SOUTH CAROLINA ELECTRIC & GAS COMPANY

August 8, 1983

Subject: Virgil C. Summer Nuclear Station  
Docket No. 50/395  
Operating License No. NPF-12  
Dropped Rod Methodology  
License Condition 2.C.22

Westinghouse has performed a plant specific analysis for the Virgil C. Summer Nuclear Station, Cycle 1, utilizing the NRC approved methodology. The results of the analysis indicate that the DNE design basis is met. Based on this evaluation, South Carolina Electric and Gas Company (SCE&G) has concluded that the interim restrictions for rod control are no longer required for Cycle 1. Attached are marked-up FSAR pages reflecting the new analysis.

Figure 15.2-11

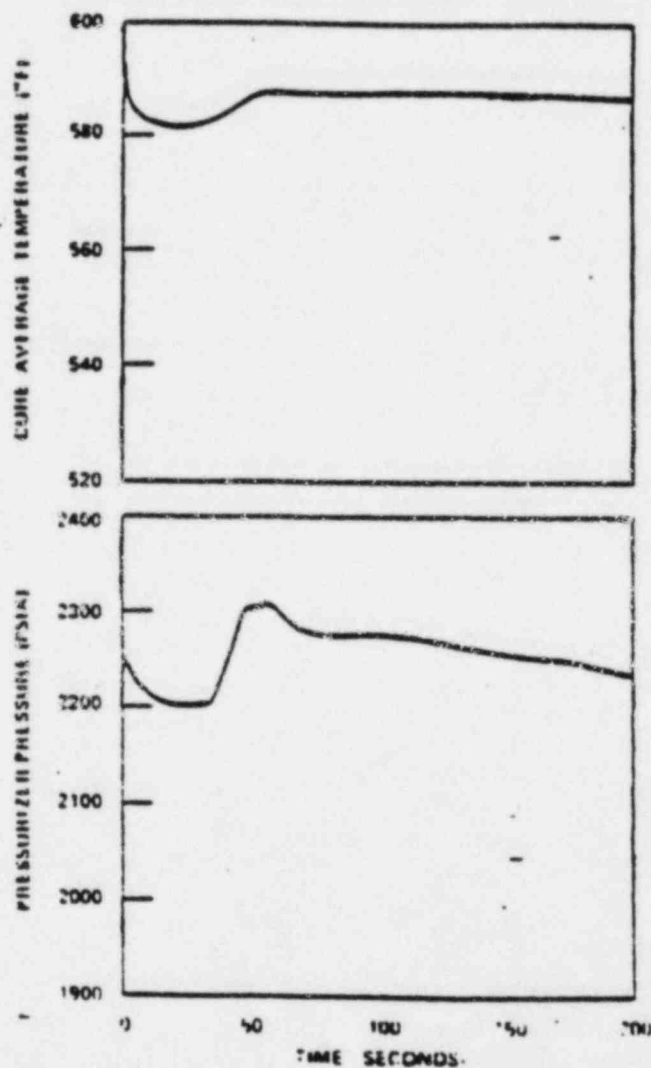
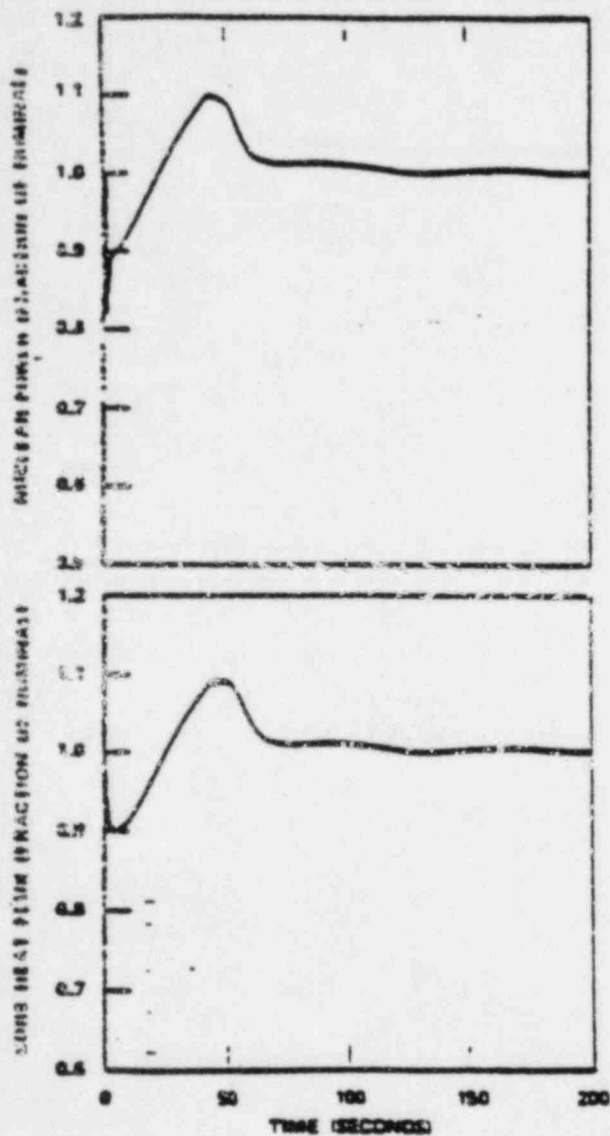
*Delete this figure*

*Insert Figure*
